Matthew C. Murphy, PE
Stonewall Structural Engineering, PLLC
9203 Baileywick Rd. #200
Raleigh, NC 27615
(919)407-8663

Re: Review of Proposed First-Floor Framing Reinforcement — 25 Dinghy Drive, Sanford, NC 27332

*Detail 1 – Repair Schematic
(Provided by Tar Heel Basement Systems)*

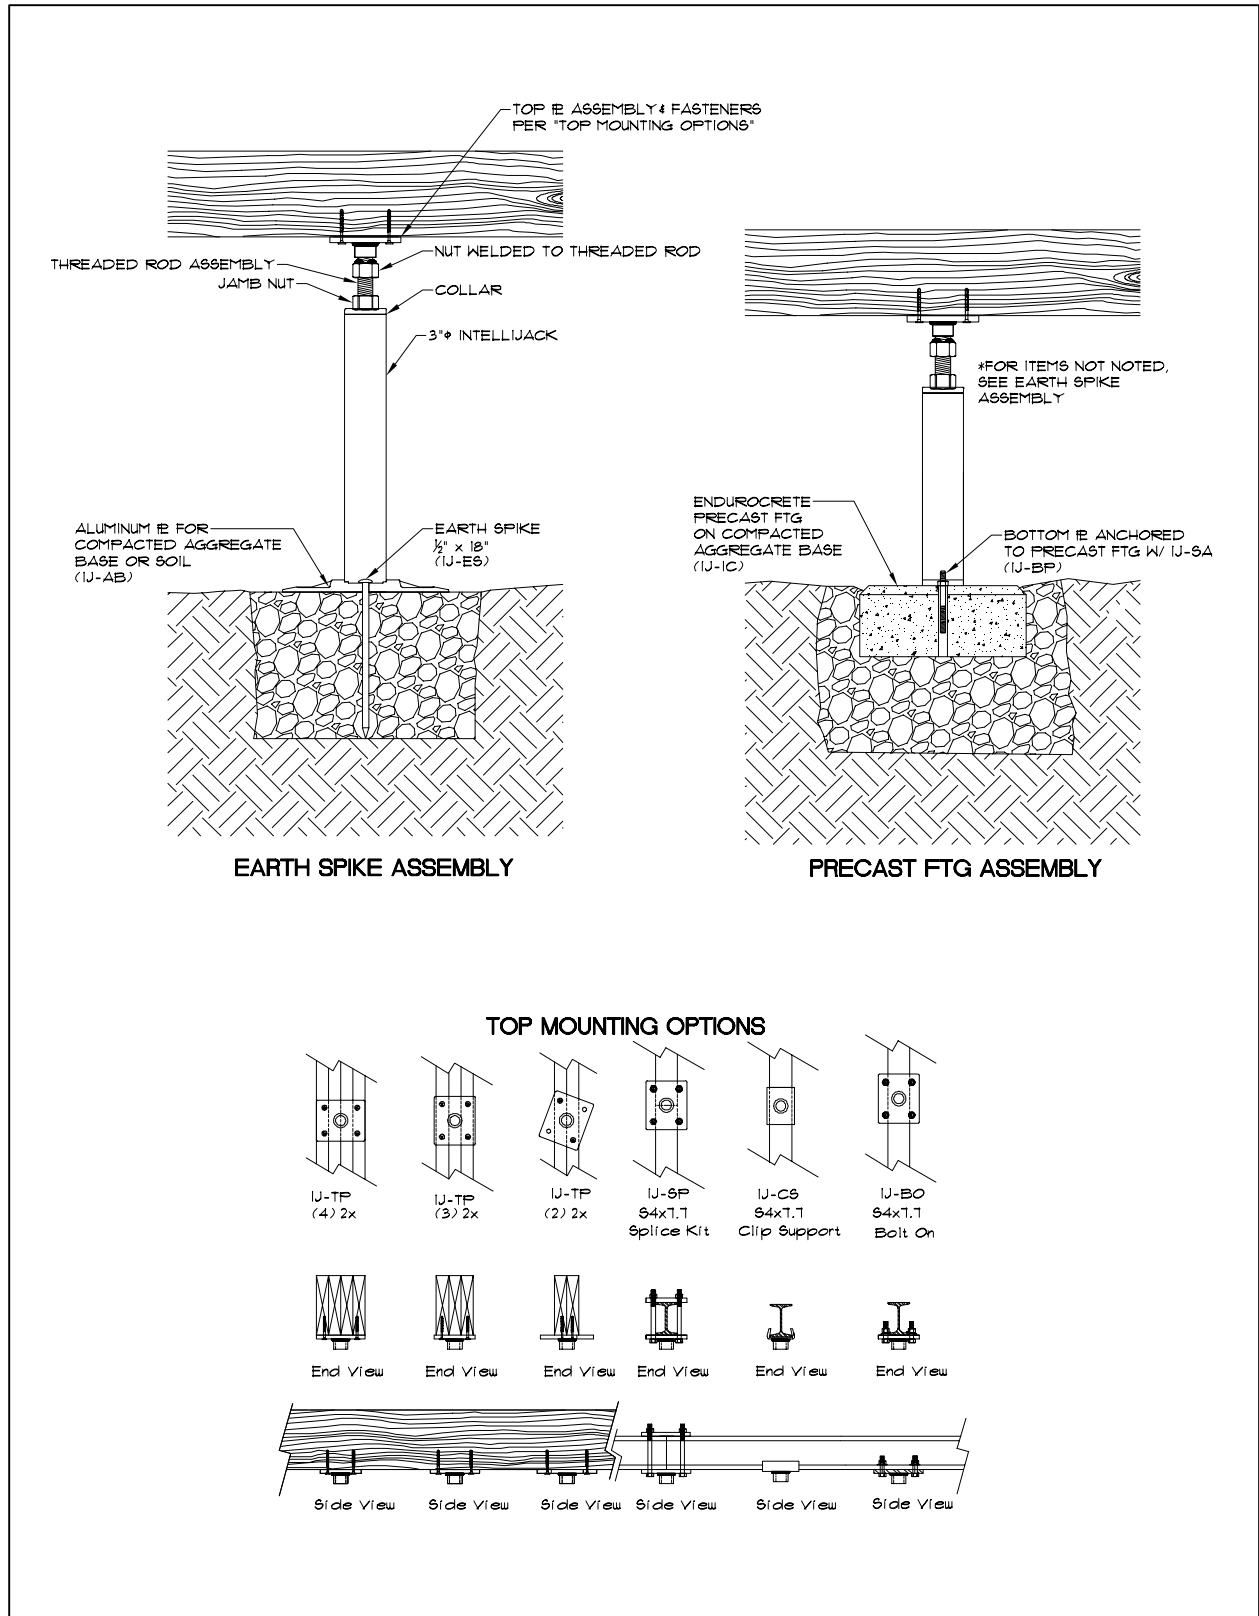
1. Install the proposed supplemental S4x7.7 dropped girder within the middle $\frac{1}{3}$ of the joists. The new girder should span across the locations shown in the attached repair schematic (see *Detail 1*) over IntelliJack supports on well-compacted 18"x18"x18" gravel footings spaced no more than 6'-6" apart (see *Detail 2*).
 - a. The supplemental dropped girder may be comprised of multiple segments provided splices between adjoining segments are located over supports.
 - b. Where feasible/practical, the ends of the new supplemental girder are recommended to start/stop under walls such that the changes in floor stiffness are less noticeable.
